## Part 5 Application **ACCESS REPORT**

**Reference Number:** 22100

**Client:** Homes NSW

**Site Address:** 24 Thuralilly St, Queanbeyan East NSW

Ground level of Dwelling C

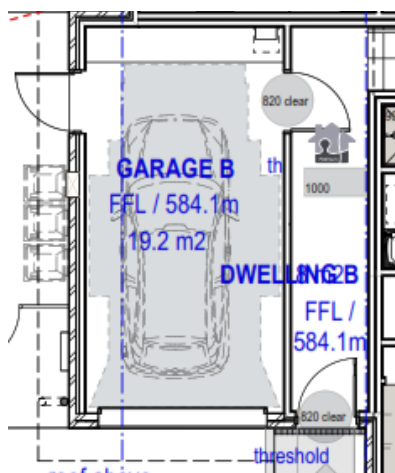
**Does not comply**

**Dwelling C does not have walls to both sides of the WC pan to be provided for min 600 wall reinforcement**

**Does not comply with Dwelling B as toilet is not provided in entry level**

## Dwelling A has been designed to comply with LHA Gold level requirements

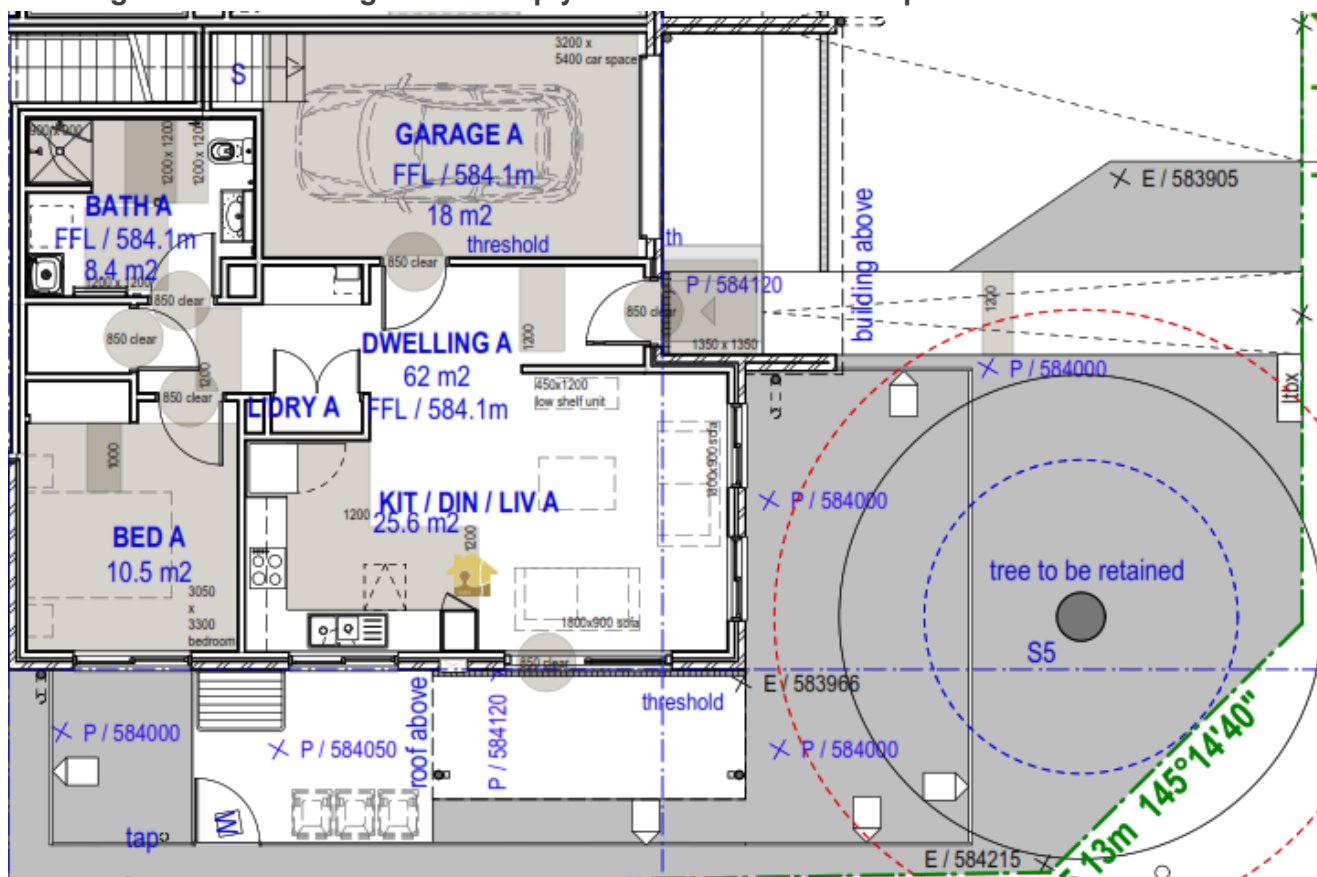
Design Element	Requirements (All dimensions noted are required to be clear of finishes as required under AS1428.1)	Compliance / Comments CC means Crown Certificate
<b>1</b> Dwelling Access	<ul style="list-style-type: none"> <li>a. Provide a safe and continuous 1M clear width pathway from front site boundary to an entry door to the dwelling.</li> <li>b. Path including any ramps and walkways to have no steps, even firm, slip-resistant surface, max 1:40 crossfall, max slope of 1:14 with landings of 1.2M every 9M and landings every 15M for 1:20 walkways. 1M clear width of ramps are required.</li> <li>c. Pathway may be provided via an associated car parking in which case the car parking space to be <ul style="list-style-type: none"> <li>▪ 3200 (width) x5400 (length),</li> <li>▪ even, firm and slip resistant, level surface of 1:40 max grade and 1:33 max grade for bitumen</li> </ul> </li> <li>d. Step ramp may be provided at an entrance doorway. The step ramp to be max 190mm height, max 1:10 grade, max 1900mm length.</li> <li>e. Level landings of 1200mm are required exclusive of the swing of the door or gate and to be provided at the head and foot of the ramp.</li> </ul>	<p>Complies Details to be verified at CC stage of works</p> <p>N/A Access is provided from the site boundary.</p> <p>N/A</p> <p>N/A</p>

<b>2</b> Dwelling entry	<ul style="list-style-type: none"> <li>a. Dwelling Entry should provide an entrance door with <ul style="list-style-type: none"> <li>i. min clear opening width of door to be 820mm</li> <li>ii. Step free threshold of max 5mm with rounded or beveled lip</li> </ul> </li> </ul>	<p>Complies Details to be verified at CC</p>

<b>3</b> Internal doors and corridors	<ul style="list-style-type: none"> <li>a. Doors to rooms on the entry level used for living, dining, bedroom, bathroom, kitchen, laundry and sanitary compartments to be               <ul style="list-style-type: none"> <li>i. 820mm clear opening and</li> <li>ii. provided with a level threshold of max 5mm between abutting surfaces with rounded or beveled lip</li> </ul> </li> <li>b. Internal corridors and passageways to doorway to be min 1M clear (measured from skirting to skirting)</li> </ul>	<p>Complies Details to be verified at CC stage of works</p> <p>Complies Details to be verified at CC stage of works</p>
<b>4</b> Toilet	<ul style="list-style-type: none"> <li>a. One Toilet to be provided on the ground or entry level that provides,               <ul style="list-style-type: none"> <li>i. Min 900mm between walls or amenities</li> <li>ii. Min 1200mm clear space in forward of the WC pan exclusive of door swing.</li> <li>iii. The toilet pan to be positioned in the corner of a room to enable handrails</li> </ul> </li> </ul>	Complies Details to be verified at CC stage of works

<b>5</b> Shower	<ul style="list-style-type: none"> <li>a. One bathroom should feature a slip resistant, hobless shower recess. Shower screens are permitted provided they can be easily removed at a later date.</li> <li>b. The shower recess should be located in the corner of the room to enable the installation of grabrails at a future date.</li> </ul> <p>For hobless specification please see Australian Standard AS3740-3.6. Reinforcement guidelines for walls in bathrooms and toilets are found in element 6</p>	Complies Details to be verified at CC stage of works
<b>6</b> Reinforcement of bathroom & toilet walls	<ul style="list-style-type: none"> <li>a. Except for walls constructed of solid masonry or concrete, the walls around the shower, bath (if provided) and toilet should be reinforced to provide a fixing surface for the safe installation of grabrails.</li> <li>(b), (c) and (d) the walls around toilet, bath and shower to be via:               <ul style="list-style-type: none"> <li>i. Noggins with a thickness of at least 25mm</li> <li>ii. Sheeting with a thickness of at least 12mm</li> </ul> </li> </ul>	<p>Complies Details to be verified at CC stage of works</p> <p>Complies Details to be verified at CC</p>
